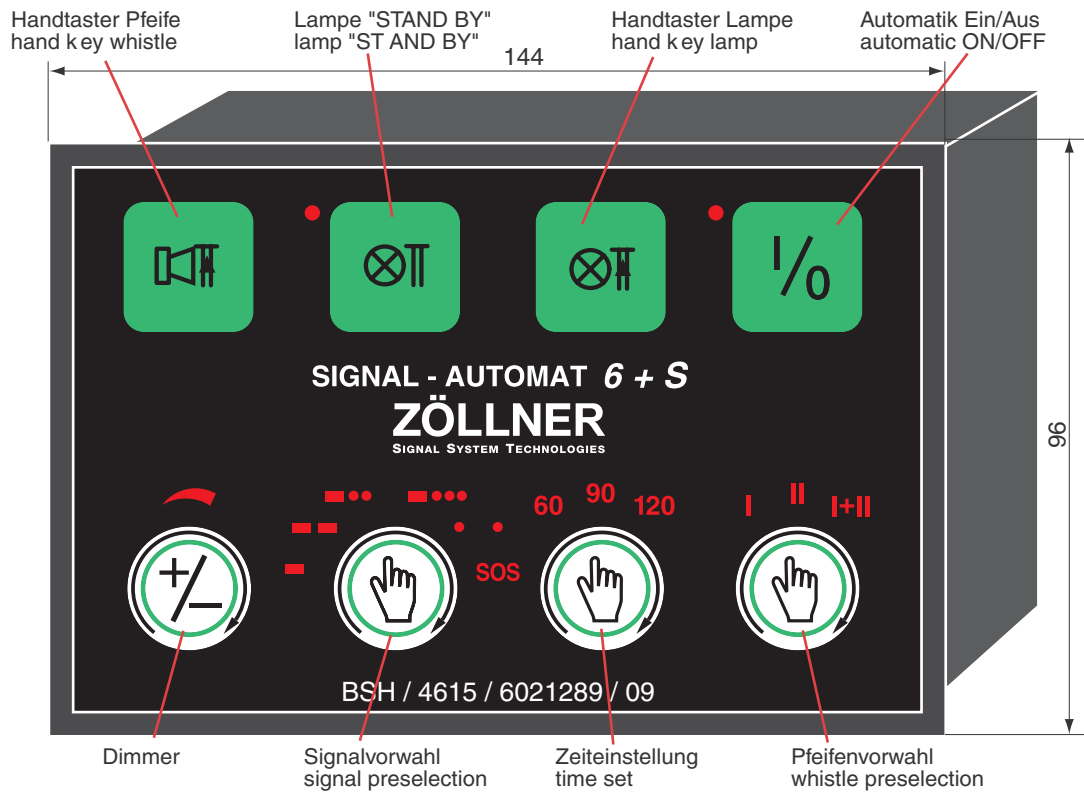
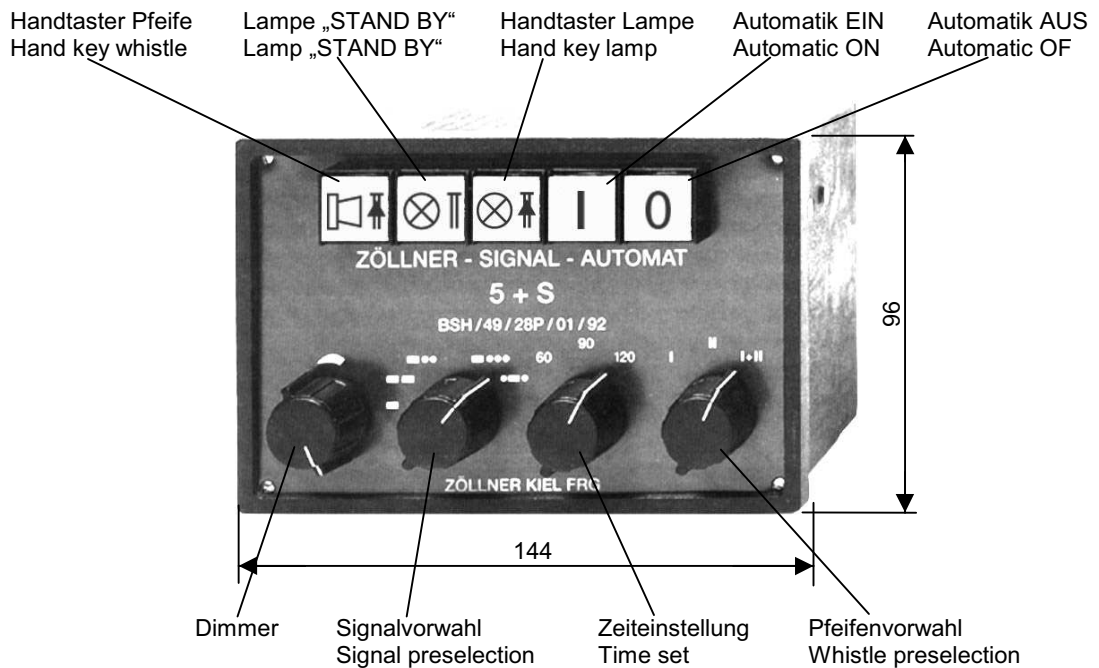
All dimensions remain unchanged.
The 6+S has a membrane keyboard
while the 5+S had keys and switches.

6+S

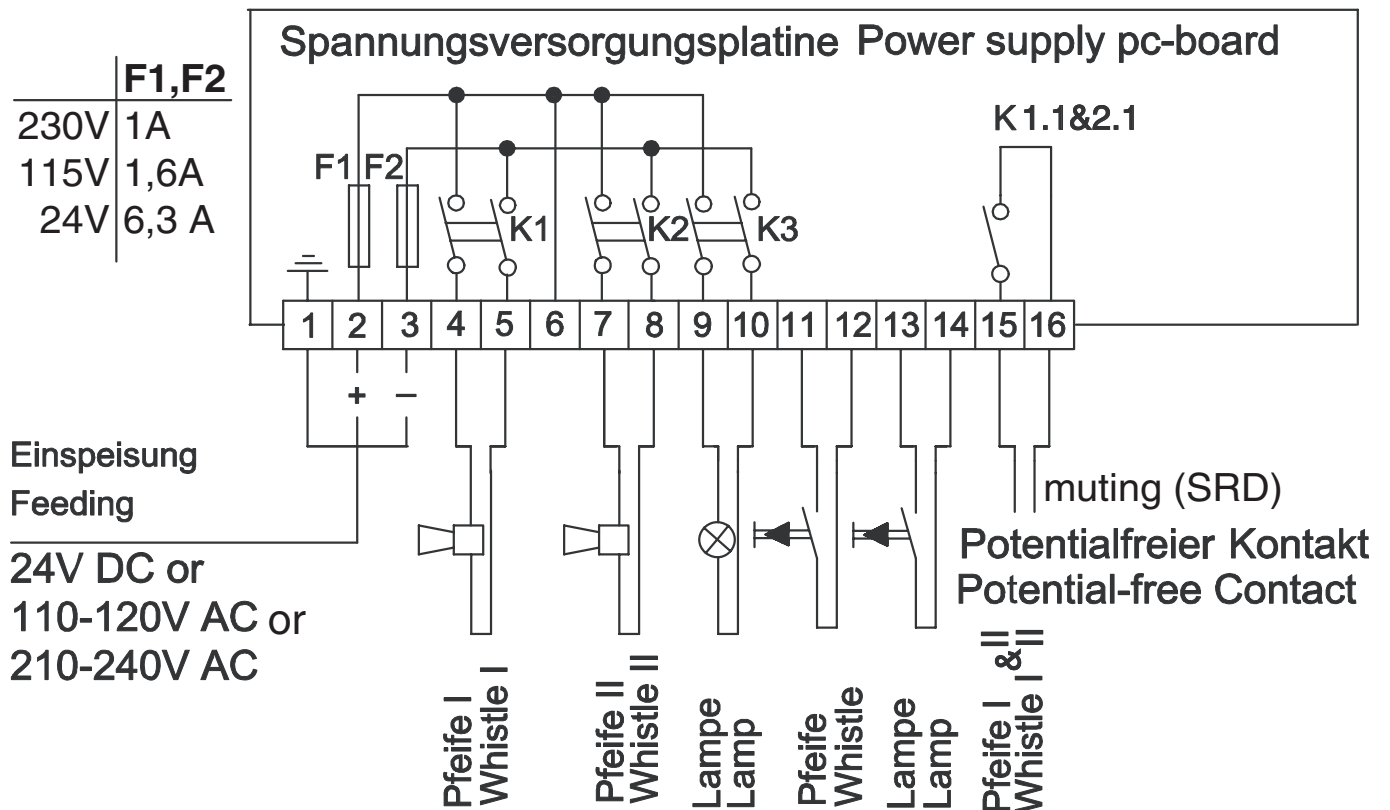
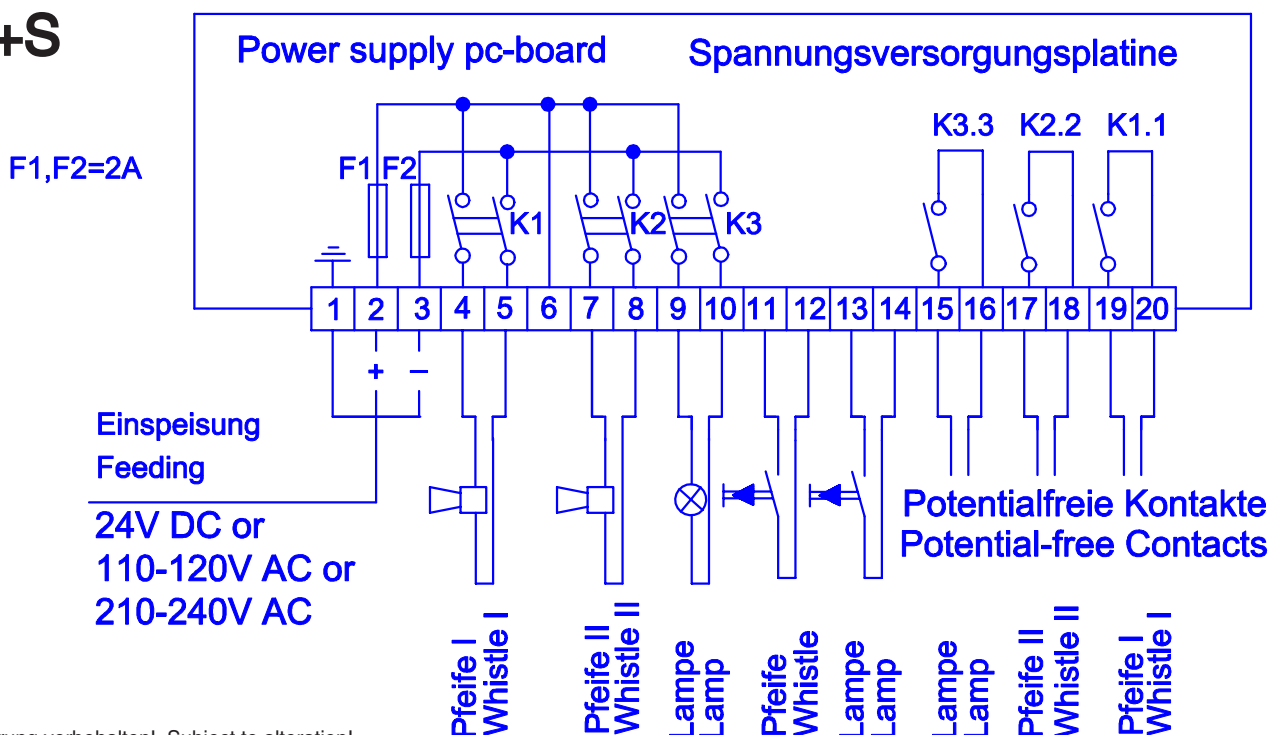
All connections remain unchanged, but type 6+S no more has potential free contacts (lamp/horn)
